DOCUMENT NO. <b>APP-GW-GLR-156</b>	REVISION <b>1</b>	PAGE <b>1 of 2525</b>	OPEN ITEMS <b>N</b>
DOCUMENT STATUS: <b>DES</b>		<b>AP1000®</b> SAFETY CLASS: <b>NA</b>	Westinghouse Acceptance of <b>AP1000</b> Design Partner Document by:  <b>N/A</b> (Print Full Name)  (Signature/Date)
LICENSING REVIEW STATUS: Not Required			
PLANT APPLICABILITY: <input checked="" type="checkbox"/> All <b>AP1000</b> Plants except: No Exceptions			
<input type="checkbox"/> Only the following plants:

ALTERNATE DOCUMENT NUMBER: **WCAP-17524-NP-A**ORIGINATING ORGANIZATION: **Westinghouse Electric Company, LLC**TITLE: **AP1000 Core Reference Report**

Figure 2-1 Comparison of the Previous Protective Grid and the RPG

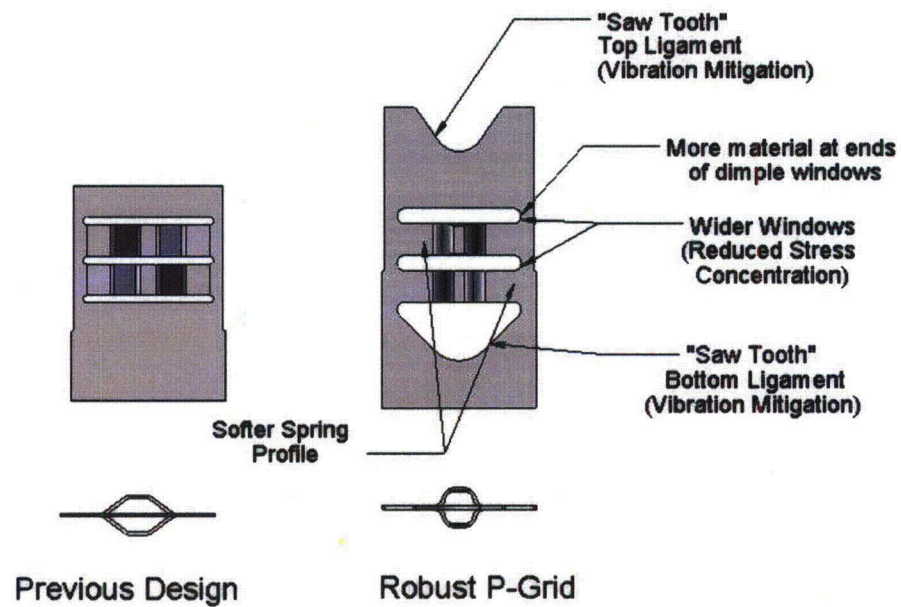
Figure 2-1 provides an illustrative comparison of the inner grid straps between the previous P-grid design and the RPG design. Figure 2-2 shows the difference in the number of supports used on the previous P-grid design versus the RPG design.

Figure 4.2-1

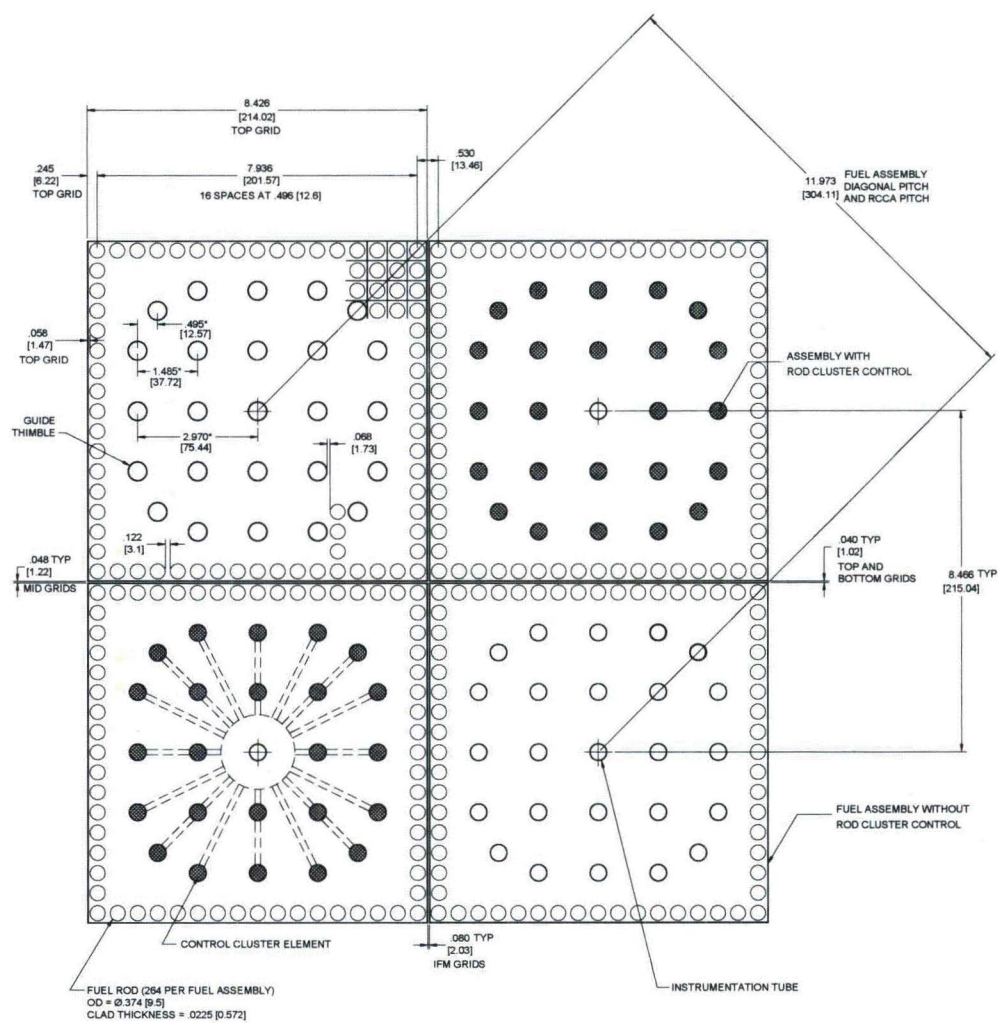
[4.2-51]	4.2.6 Reference 27	Added new reference CENPD-404-P-A, Revision 0, "Implementation of ZIRLO™ Cladding Material in CE Nuclear Power Fuel Assembly Designs," November 2001 - consistent with the change to 4.2.3.3.2.
[4.2-52]	Figure 4.2-1	Figure has been redrawn with metric units added. The basic content of this figure has not been changed.
[4.2-53]	Figure 4.2-2	Figure has been redrawn and includes the addition of the top nozzle fuel alignment pin hole pitch dimension for clarification. Metric units have also been added. The basic content of this figure has not been changed.
[4.2-54]	Figure 4.2-3	Figure has been redrawn and metric units added. The basic content of this figure has not been changed.
[4.2-55]	Figure 4.2-4	Figure has been redrawn and metric units added. Except for pictorial representation of the number of bulges below the top grid, the basic content of this figure has not been changed.

**Comment [A58]:** [4.2-52]

Figure 4.2-5

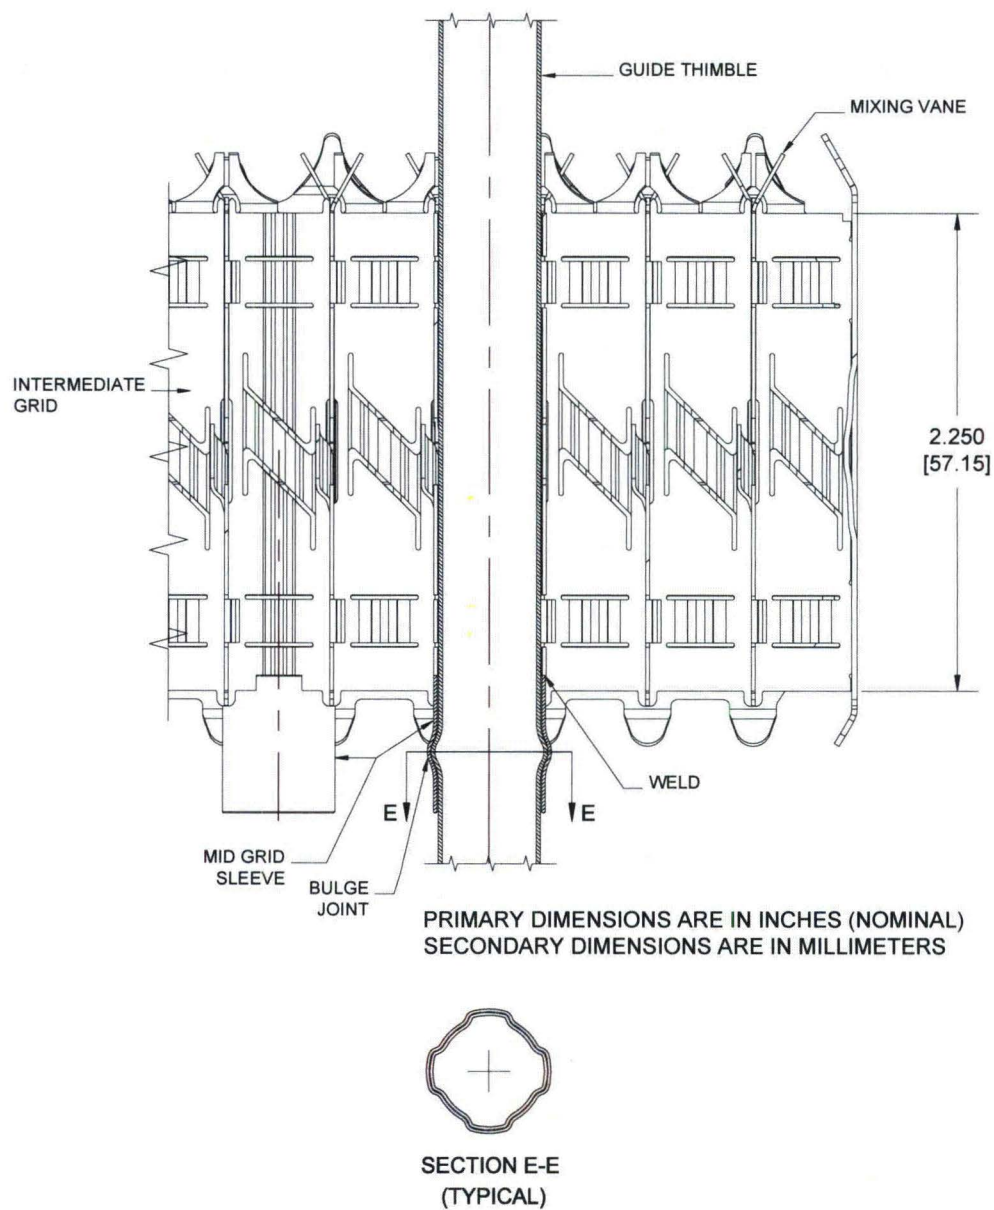
[4.2-56]	Figure 4.2-5	Figure has been redrawn with grid height dimension added consistent with DCD Revision 19 which stated that the dimension will be provided in the Core Reference Report. Metric units have also been added. The basic content of this figure has not been changed.
[4.2-57]	Figure 4.2-6	Figure has been redrawn with dimensions added consistent with DCD Revision 19 which stated that the dimension will be provided in the Core Reference Report. Metric units have also been added. The basic content of this figure has not been changed.
[4.2-58]	Figure 4.2-7	Figure has been redrawn. With the exception of the number of P-Grid spacers (changed from 4 to 8), the basic content of this figure has not been changed.
[4.2-59]	Figure 4.2-8	Figure has been redrawn to remove any stray marks. No changes have been made to the content of this figure.
[4.2-60]	Figure 4.2-9	Figure has been updated based on enhanced RCCA design options. Metric units have also been added.

Comment [A62]: [4.2-56]

Figure 4.2-10

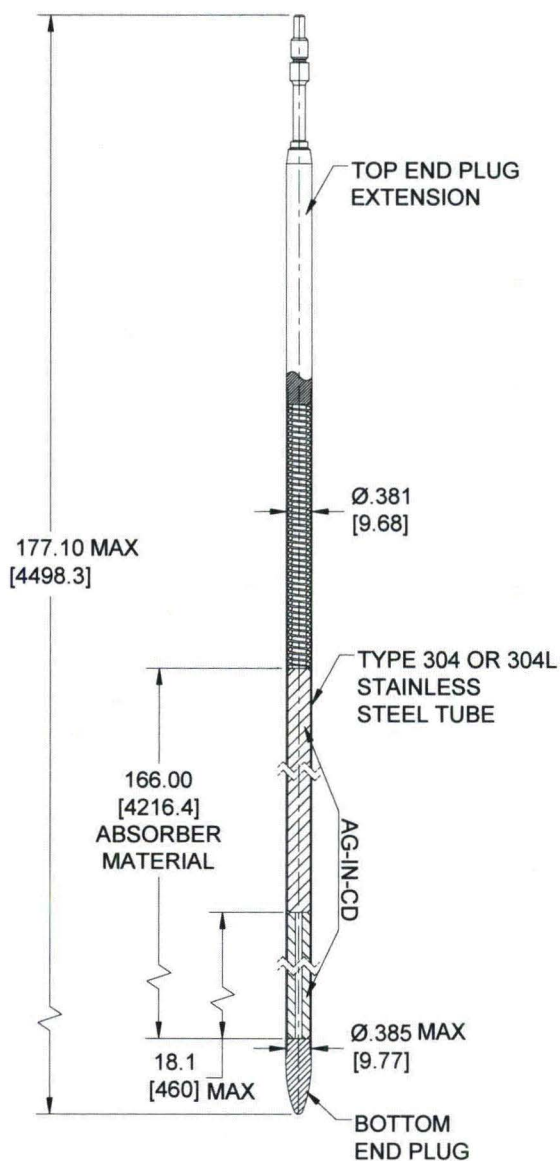
[4.2-61]	Figure 4.2-10	Figure has been updated based on enhanced RCCA design options. Metric units have also been added.

Comment [A67]: [4.2-61]

Figure 4.2-11

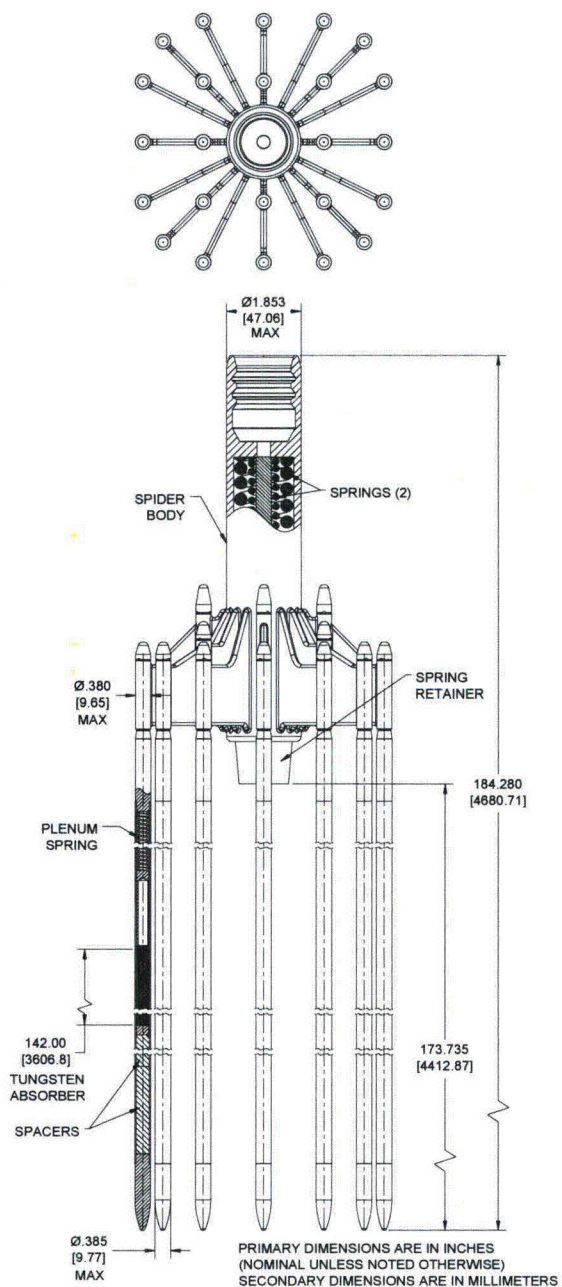
[4.2-62]	Figure 4.2-11	Figure has been updated based on enhanced RCCA design options and tungsten GRCA design. Metric units have also been added.
[4.2-63]	Figure 4.2-12	Revised figure from "Discrete Burnable Absorber Assembly" to "Wet Annular Burnable Absorber Assembly" consistent with the advanced first core design change as described in sub-section 4.2.2.3.3.
[4.2-64]	Figure 4.2-13	Deleted figure of "Burnable Absorber Rod Assembly (Pyrex) Borosilicate Glass" and replaced with "Not used" consistent with the advanced first core design change as described in sub-section 4.2.2.3.3.
[4.2-65]	Figure 4.2-14	Figure has been redrawn and metric units added. The basic content of this figure has not been changed.
[4.2-66]	Figure 4.2-15	Figure has been redrawn and metric units added. In addition, the source length has been corrected from 97 to 88 in. for consistency with Section 4.2.2.3.4, which already correctly specified the length as 88 in.

Comment [A68]: [4.2-62]

Figure 4.2-12

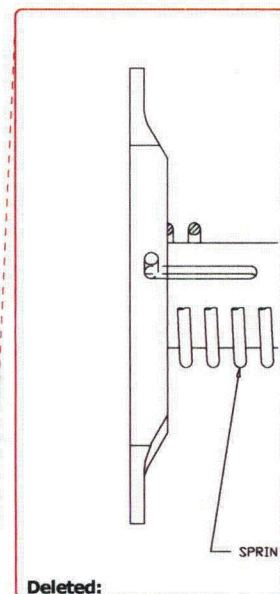
Comment [A69]: [4.2-63]
